October 29, 2015
BOARD OF COUNTY COMMISSIONERS
ORANGE COUNTY, FLORIDA

ADDENDUM NO. 5
IFB NO. Y15-771 PH
ORANGE COUNTY SOUTH WATER RECLAMATION FACILITY
PHASE V IMPROVEMENTS

NTPS PLC-16A RISER DIAGRAM

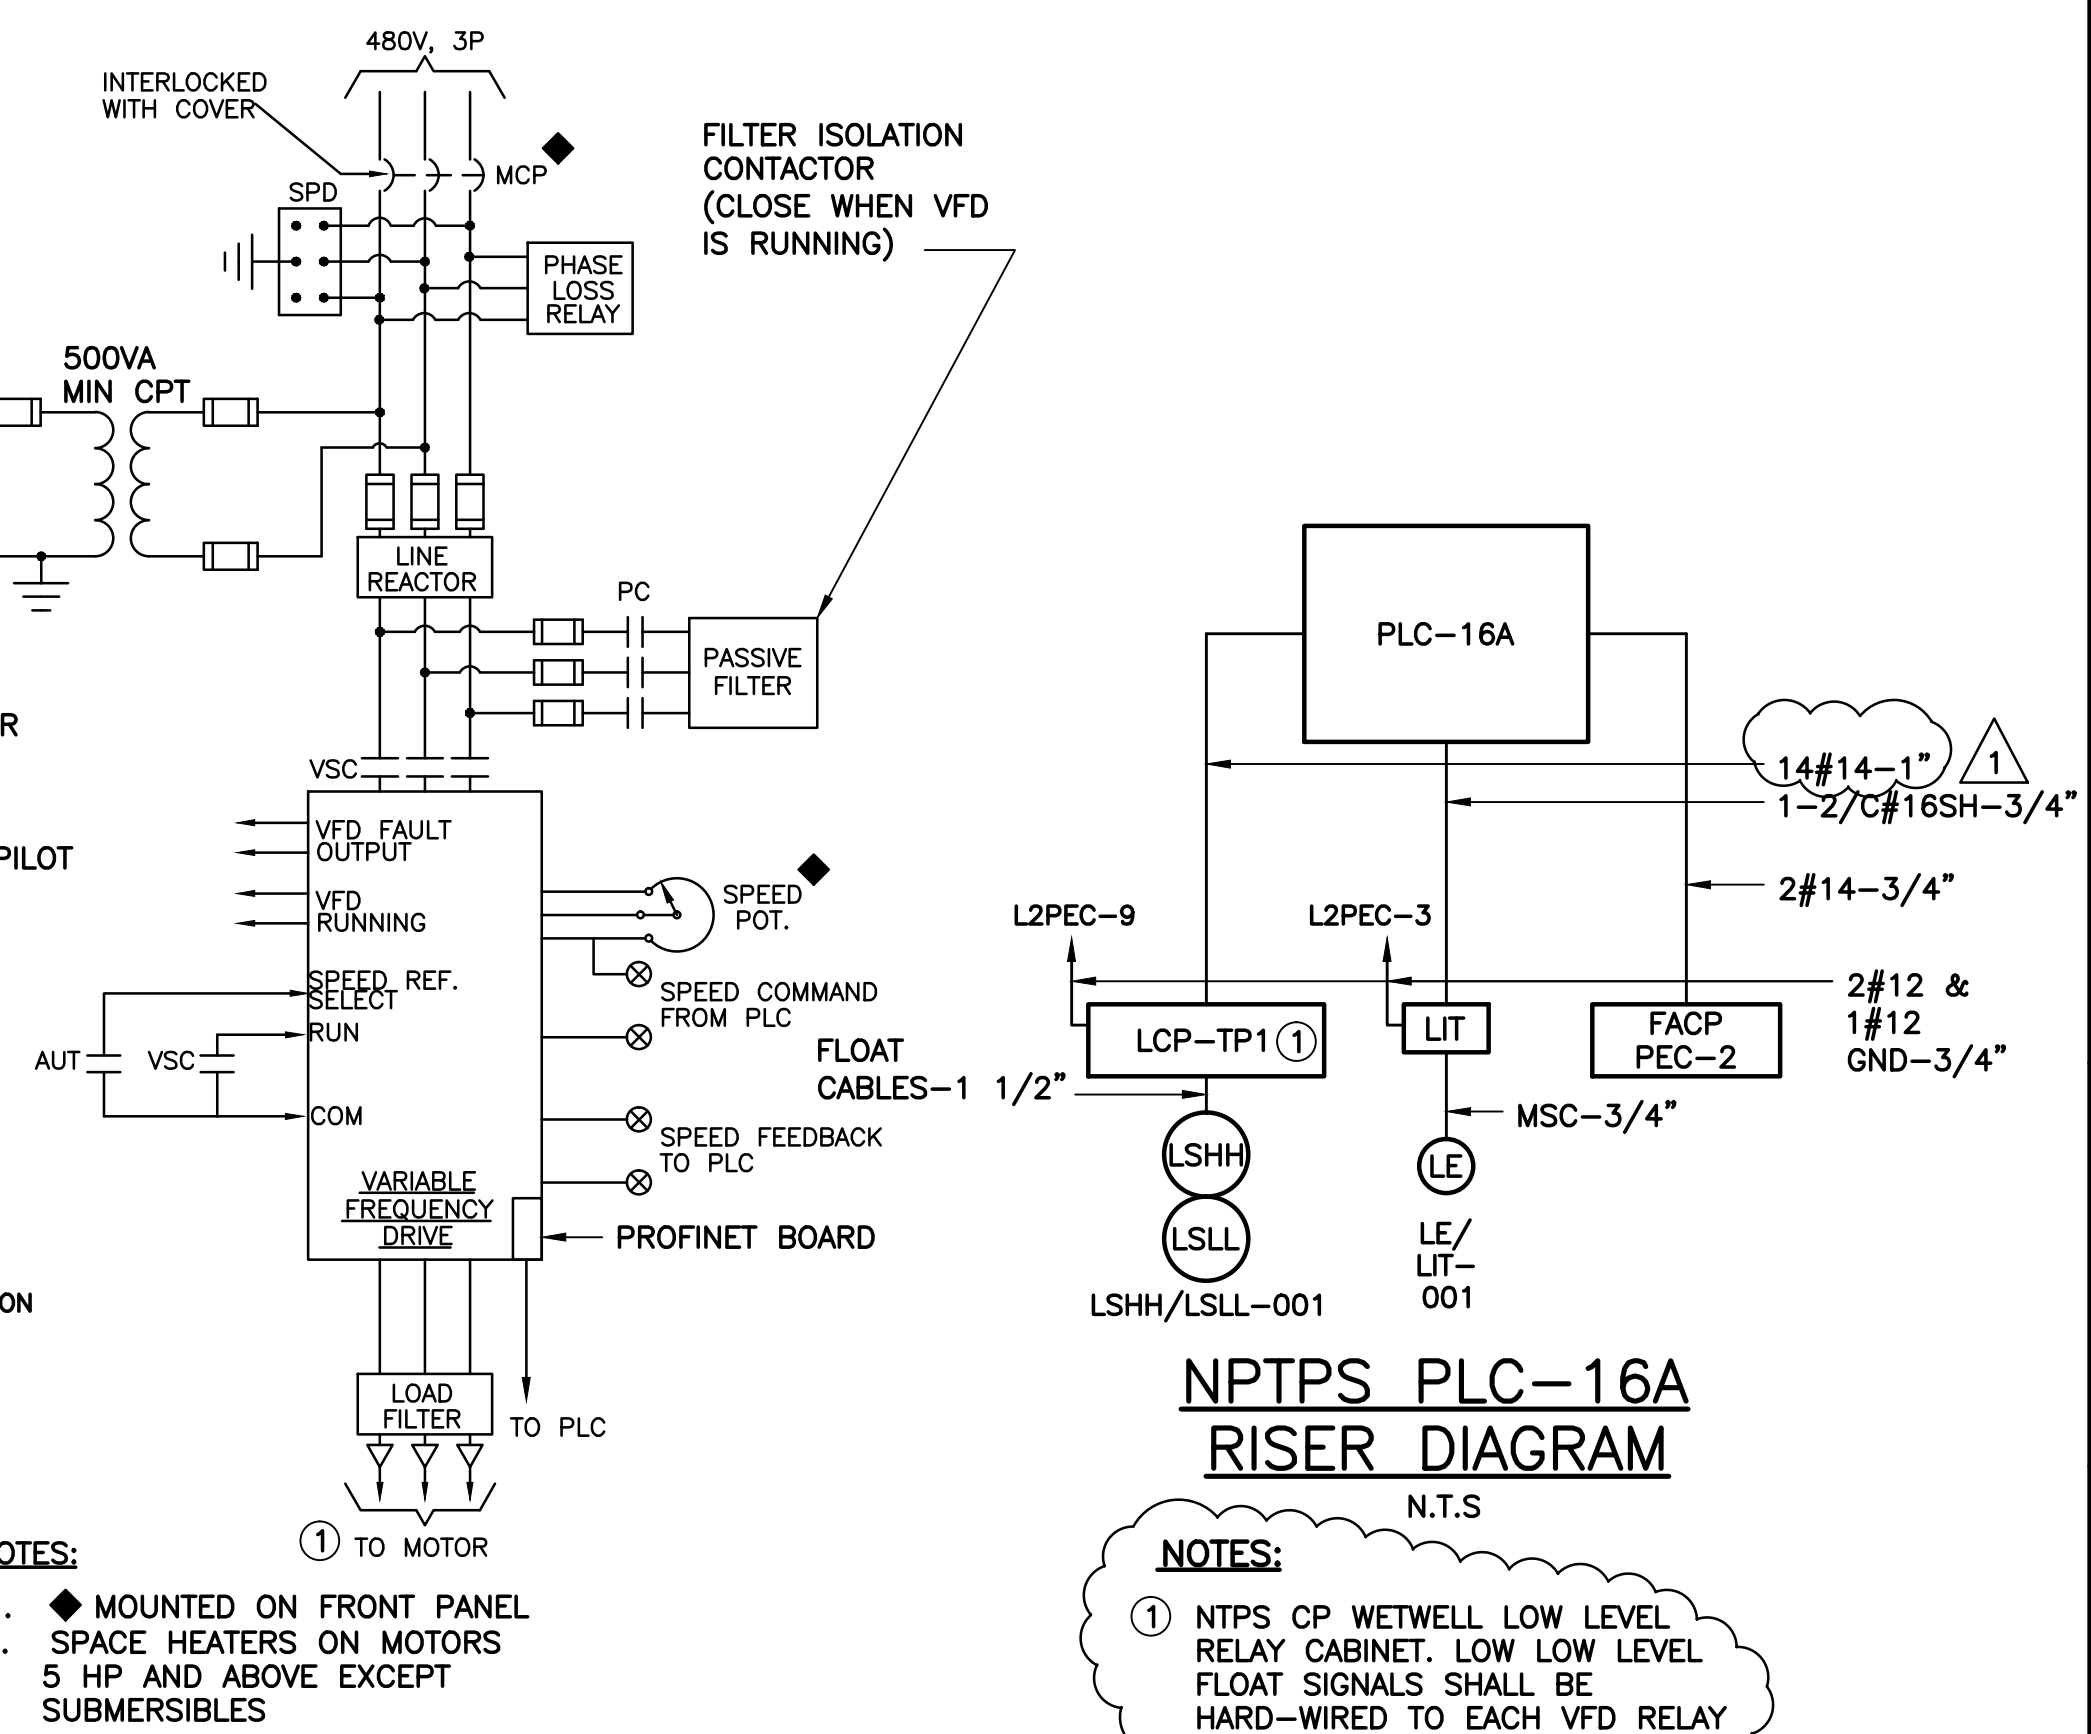
26. Sheet I-14, in addition to the low level indication to the PLC, add an electrical line from the interlock diamond of LCP-TP1 to the interlock diamond of each VFD with the wire transitioning through PLC-16A to each VFD to show the hard wired interlock on low level.

27. Sheet I-15, in addition to the low level indication to the PLC, add a PLC input labeled Equalization High High Wetwell Level. Also add an electrical line from the interlock diamond of LCP-EQ1 to the interlock diamond of each VFD with the wire transitioning through PLC-15B to each VFD to show the hard wired interlock on low level.
